**CALIFORNIA COASTAL COMMISSION**

**STAFF REPORT: REGULAR CALENDAR**

**APPLICATION NO.** 4-98-319

**PROJECT LOCATION:** 21900 Saddle Peak Road, Malibu, Los Angeles County

EXHIBIT NO. 5  
APPLICATION NO.  
Greenhut  
4-98-319  
Site Plan COP 587-818  
Note: Topography

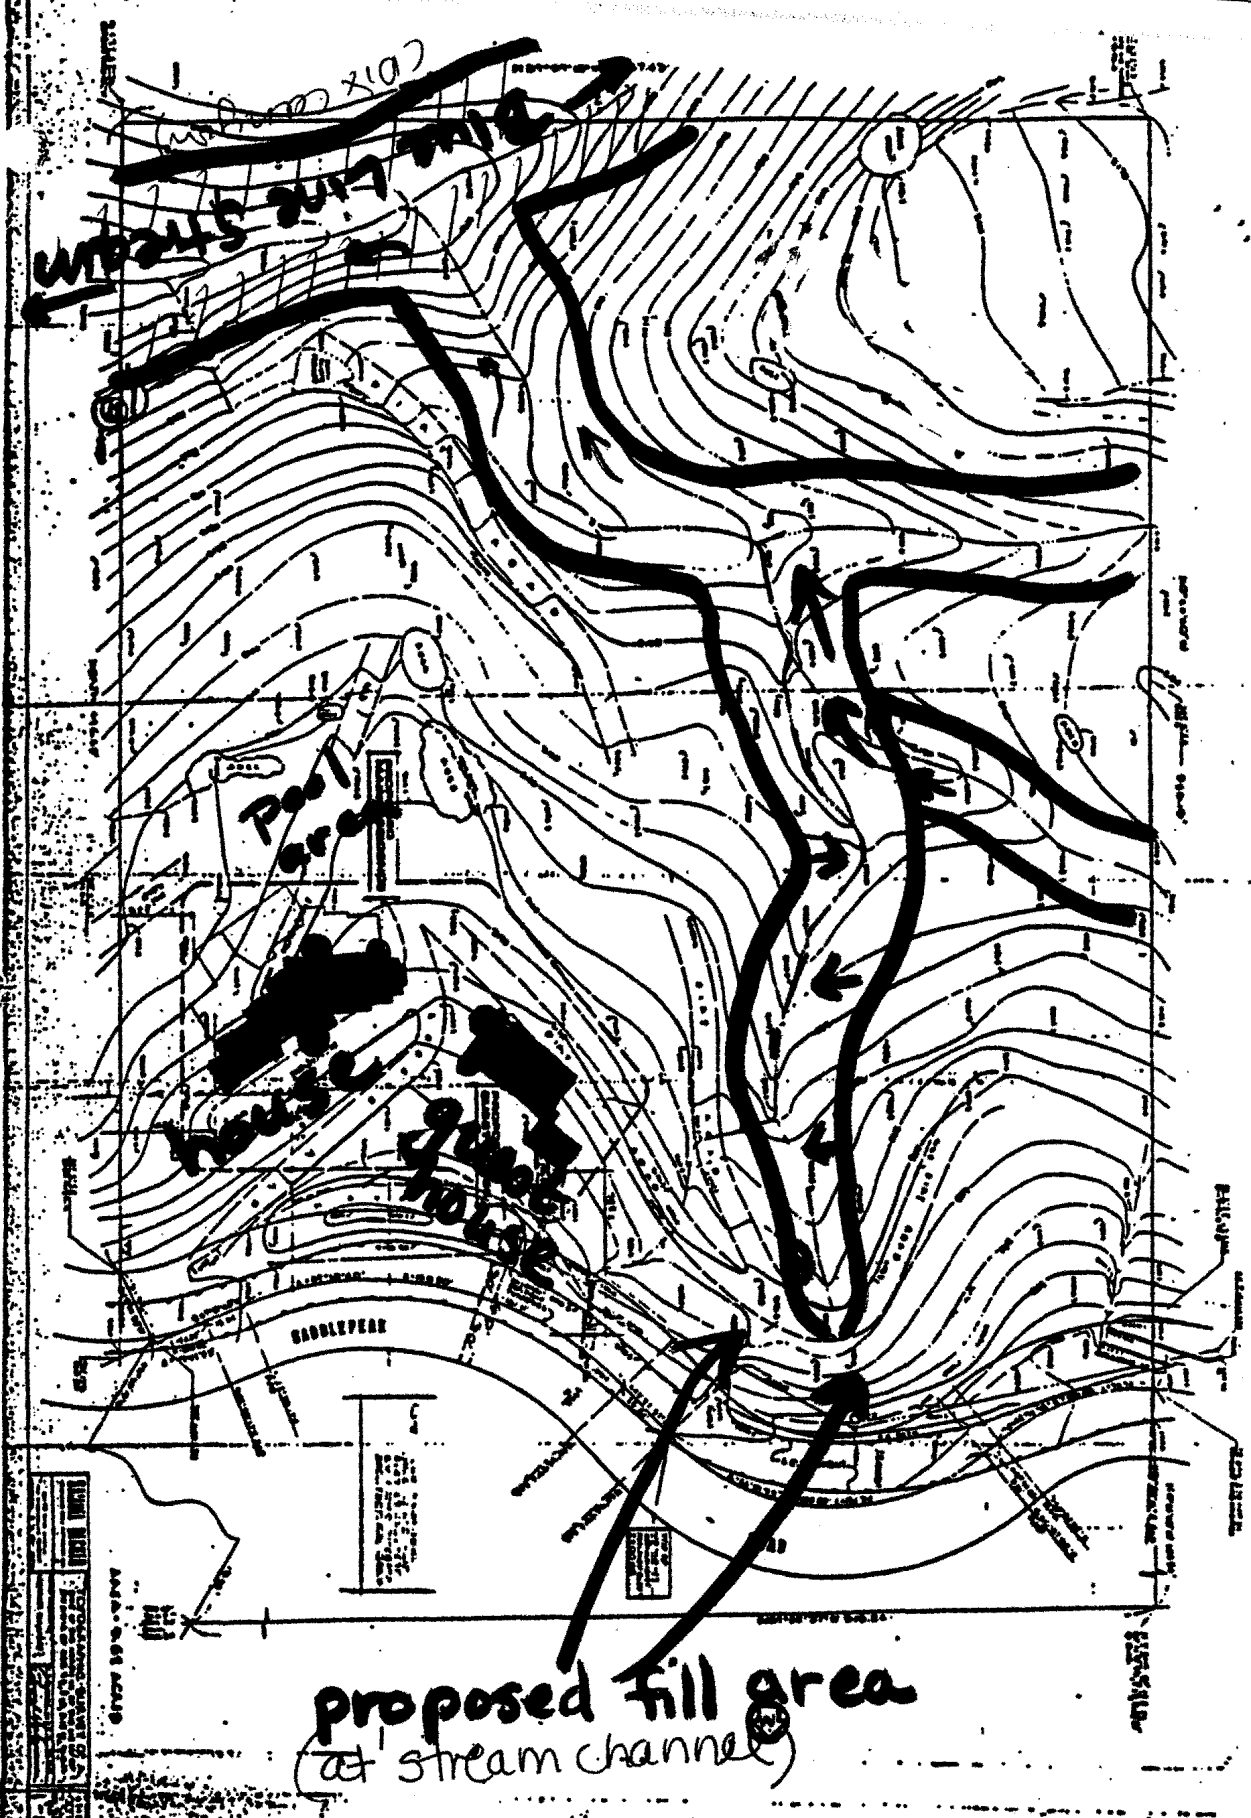
In addition, filling the mouth of the small canyon that descends from Saddle Peak Road (See Exhibit 5) to construct the proposed project will alter the natural contours visible from Saddle Peak Road and substitute a view of a vehicle parking lot. The Commission finds that these impacts, including excessive landform alteration, together with the obliteration of a natural landform visible from a designated scenic highway, combine to render the grading and construction shown on 9, 10, and 12 inconsistent with the policies of Coastal Act Section 30251. Only if the project is revised in accordance with the requirements of Special Condition 3 to eliminate these portions of the proposal would the Commission find the proposed project consistent with Coastal Act Section 30251.

**proposed fill area**  
(at stream channel)

EXHIBIT NO. 9
APPLICATION NO. Greenhut
4-98-319
Revised Plans: Delete

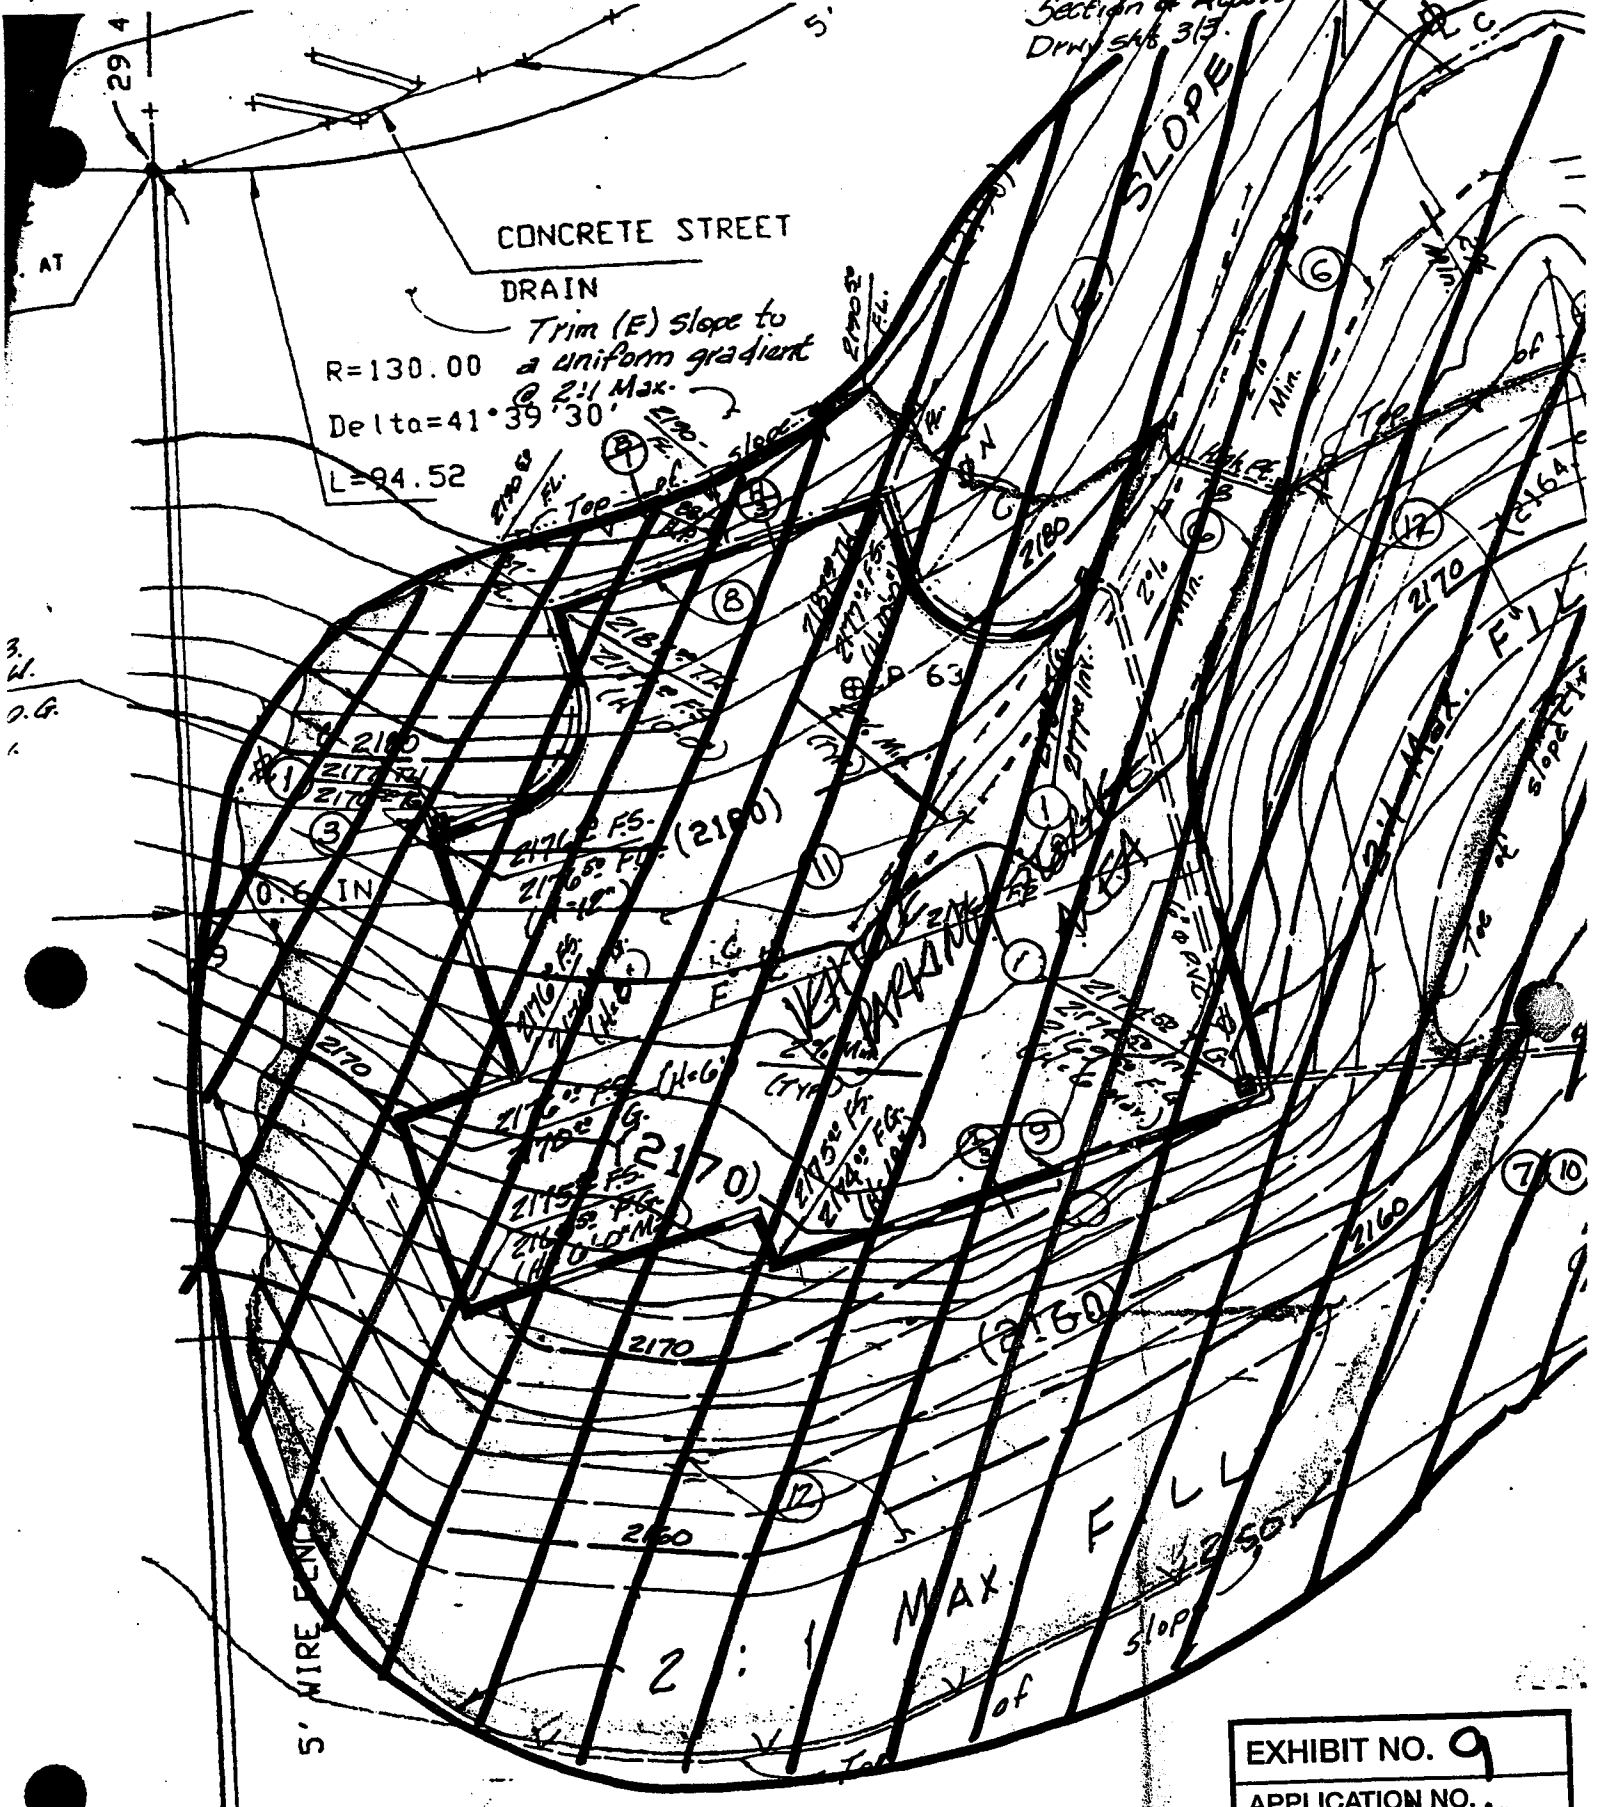
The Commission finds, therefore, that the project can only be approved if Special Condition 3 is imposed to require the applicant to prepare and submit revised plans deleting the proposed fill and lot construction (Exhibits 9 and 10), and deleting the outlying graded area (cut) situated southwest of the proposed vehicle maintenance lot and shown in Exhibit 12. The Commission further finds that if the recommendations of the

1" = 20 feet  
crosshatching: delete

- (a) The revised plans shall retain the grading shown in the area between the rear of the residence and the swimming pool and such minimal grading as may be necessary to reconfigure the existing driveway in front of the main residence to a circular form (Exhibit 11); and
- (b) The revised plans shall eliminate the grading (cut, shown in Exhibit 12, and fill shown in Exhibits 9 and 10) and construction (such as vehicle pad, culverts, retaining walls, and driveway widening and extension) shown by crosshatching in Exhibits 9, 10, and 12.

EXHIBIT NO. 10  
APPLICATION NO.  
Greenhut  
4-98-319  
Revised Plans:

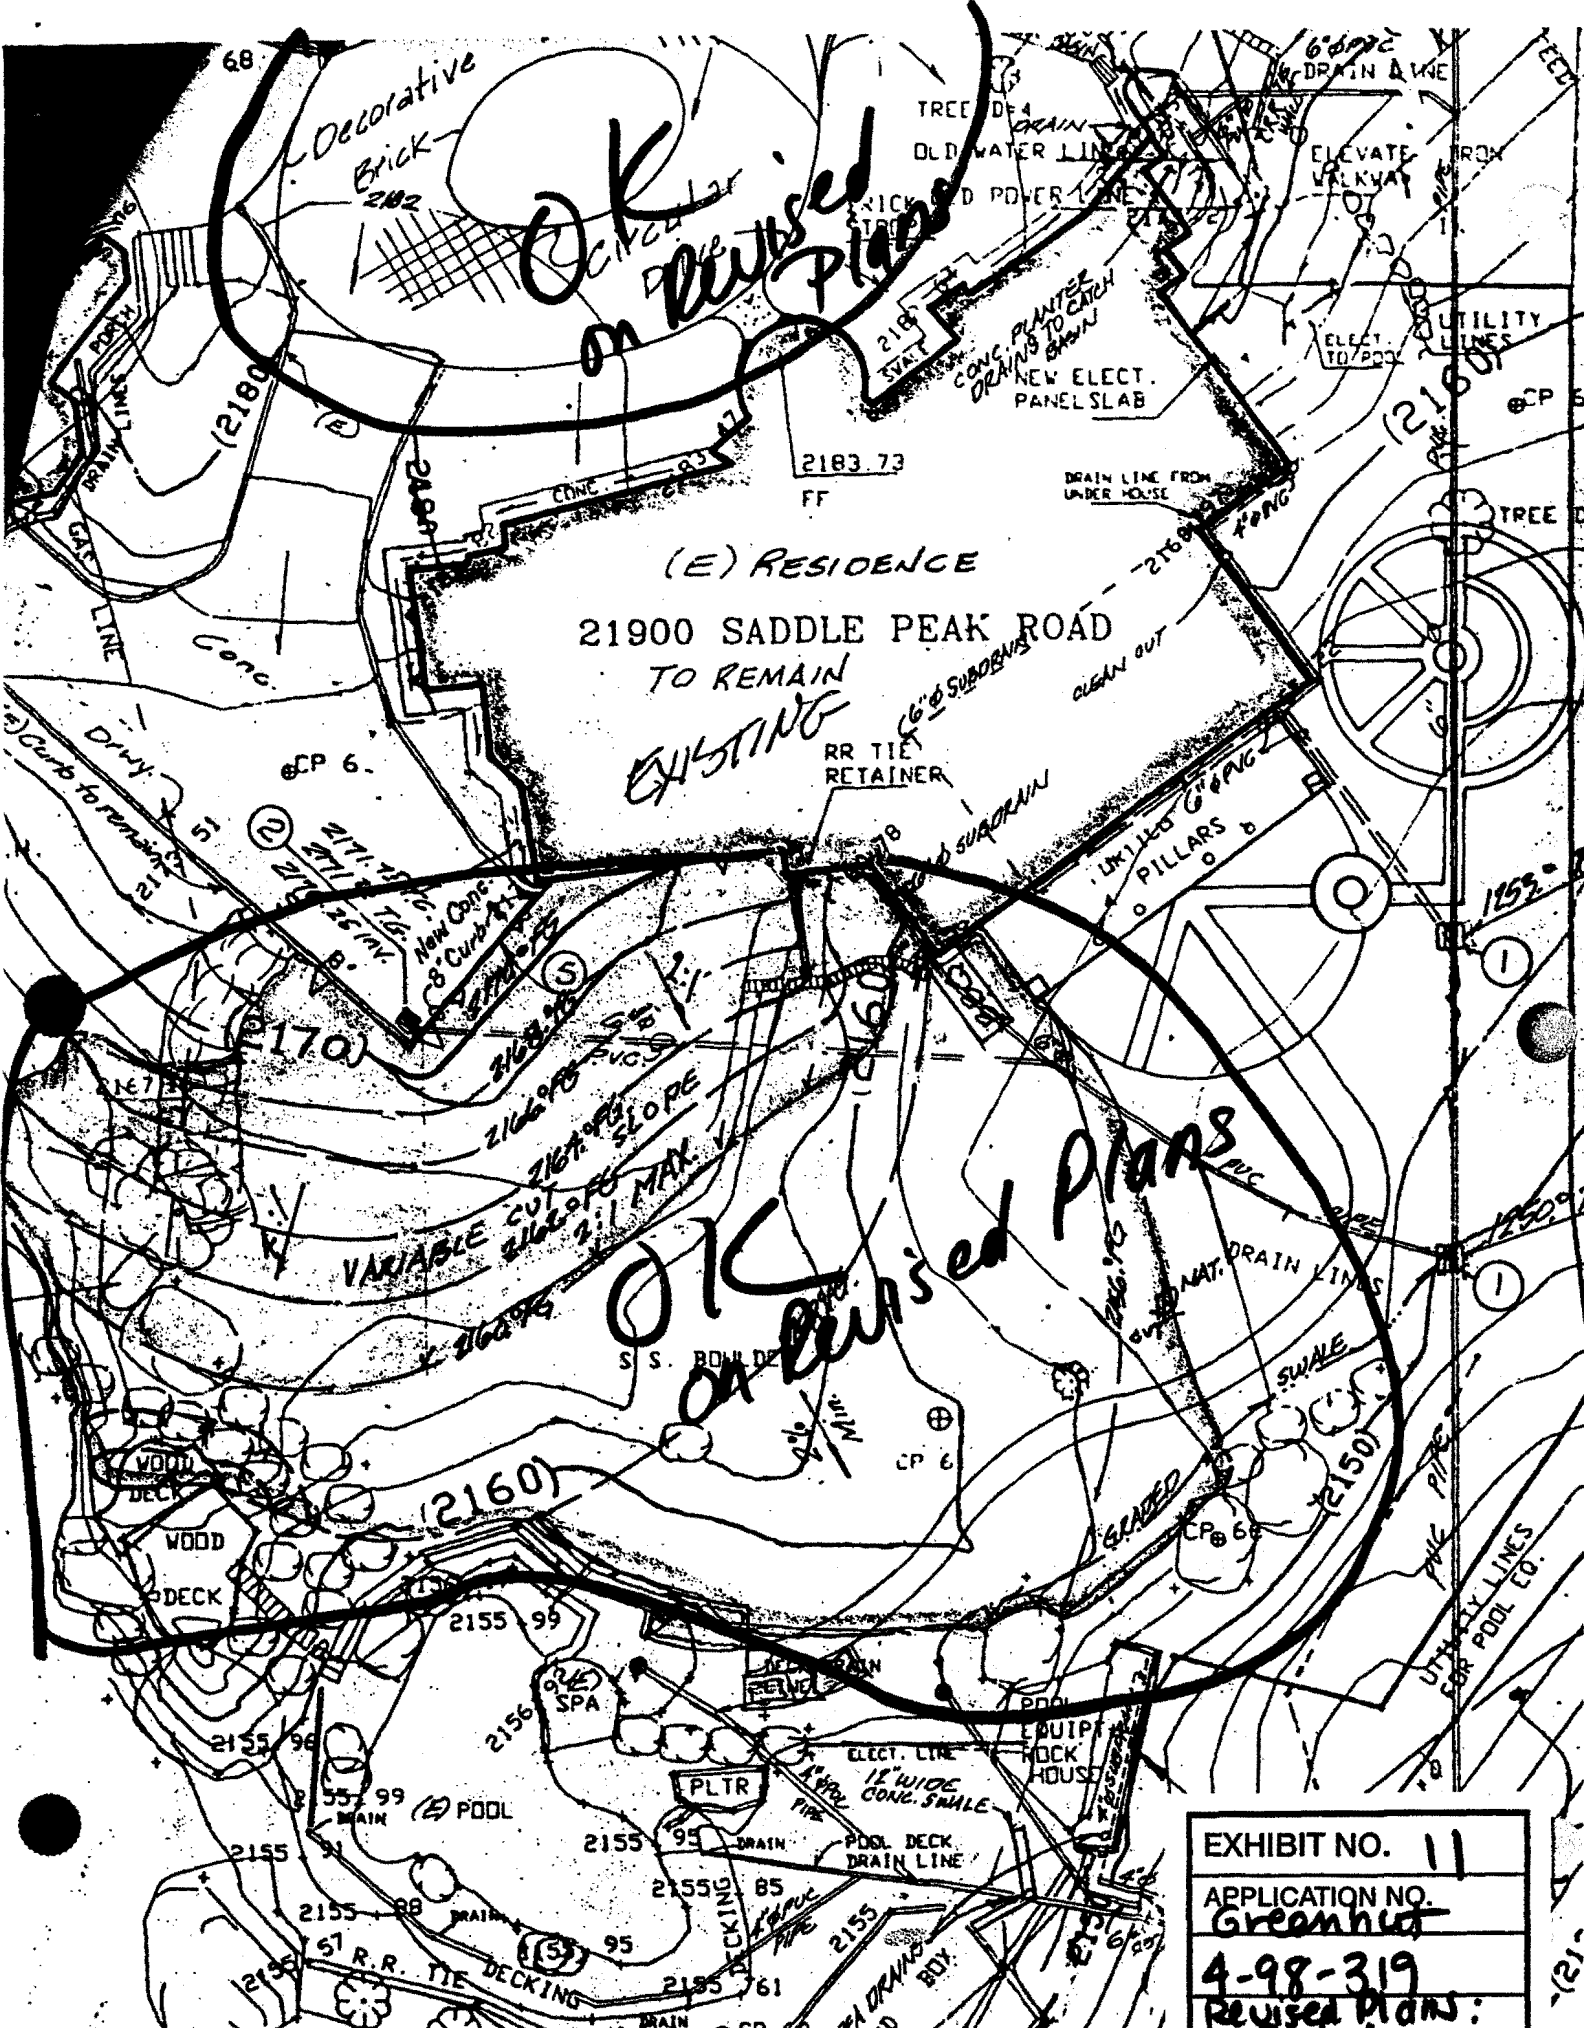
crosshatching: delete

*OK on revised plans*
